AMENDMENT OF SOLICITATION/MODIFICATION OF CONTRACT			1. CONTRACT ID CODE J	PAGE OF PAGES 1 5
2. AMENDMENT/MODIFICATION NO. 0003	3. EFFECTIVE DATE 13-Jul-2016	4. REQUISITION/PURCHASE REQ. NO.		5. PROJECT NO.(If applicable)

AMENDMENT 0003

Water Main Repairs

REVISED Date: 12-July-2016

Figure 1

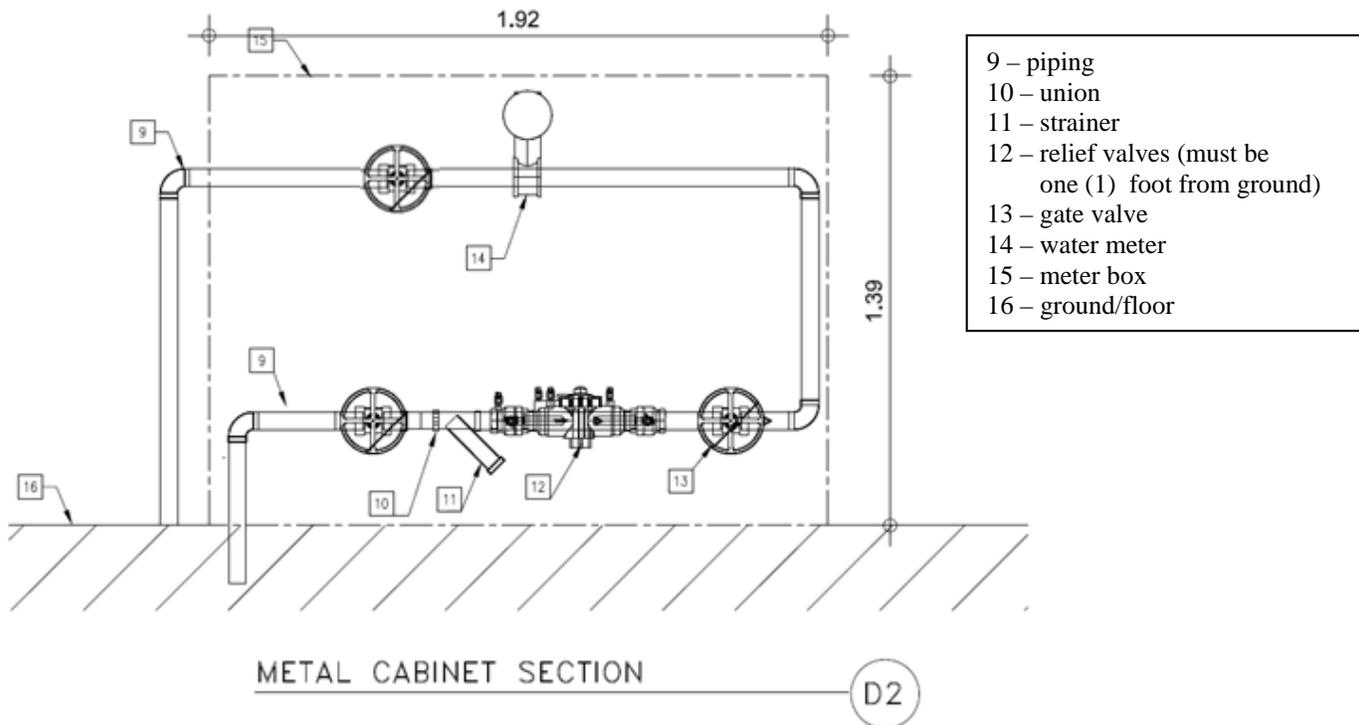
- C. Remove meter from manhole.
 - D. Excavate and bring 2 inch line to surface. Construct a metering cabinet install a 2'' Back Flow Preventer (BFP) RPZA type, provided by the government, with at least one pipe union before or after the assembly and gate valves before and after the assembly inside the cabinet. Install a new water meter, **analog (mechanical)**, inside the cabinet, with one gate valve after the meter. See Figure 1 below for a diagram of the new pipe configuration and cabinet dimensions.

- ... B97 Pool - Excavate and reveal the feed to the pool. Construct a metering cabinet at the location of the feed and install a 2'' BFP RPZA type, provided by the government, with at least one pipe union before or after the assembly and gate valves before and after the assembly inside the cabinet. Install a new water meter, similar or equal to an Endress+Hauser Proline Promag 10D, inside the cabinet, with one gate valve after the meter. See Figure 1 below for a diagram of the new pipe configuration and cabinet dimensions.
